UNITED STATES PATENT AND TRADEMARK OFFICE

| APPLICATION NO. | FILING DATE | FIRST NAMED INVENTOR | ATTORNEY DOCKET NO. | CONFIRMATION NO. |
|---------------------------|-------------|----------------------|---------------------|------------------|
| 10/647,568 | 08/25/2003 | Alexis C. Weber | DP-310020 | 3258 |

| Office Action Summary | Application No. | Applicant(s) | |

DETAILED ACTION

annular rib engages the annular groove

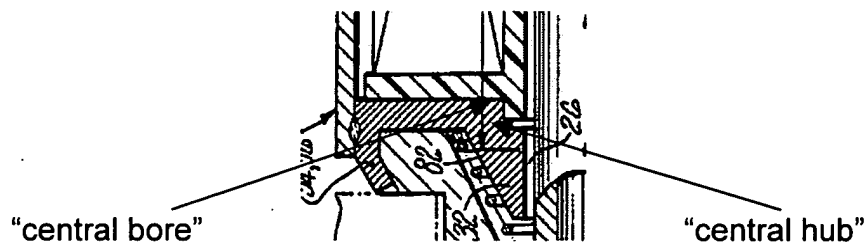
In regard to claims 6 and 22, the tubeless actuator further comprises an annular rib extending from the bobbin, an annular groove established by the secondary plate, and wherein the annular rib engages the annular groove to maintain alignment between the secondary plate and the bobbin (see picture below).

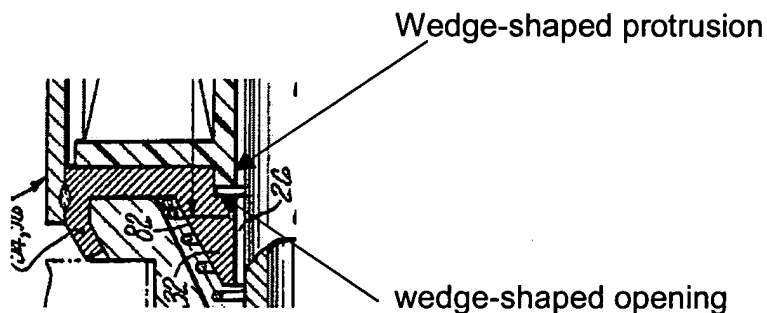
In regard to claims 7 and 23, the tubeless actuator further comprises a "central bore" established by the bobbin; a "central hub" extending from the secondary plate; and wherein the "central hub" engages the "central bore" to maintain alignment between the secondary plate and the bobbin (see picture below).
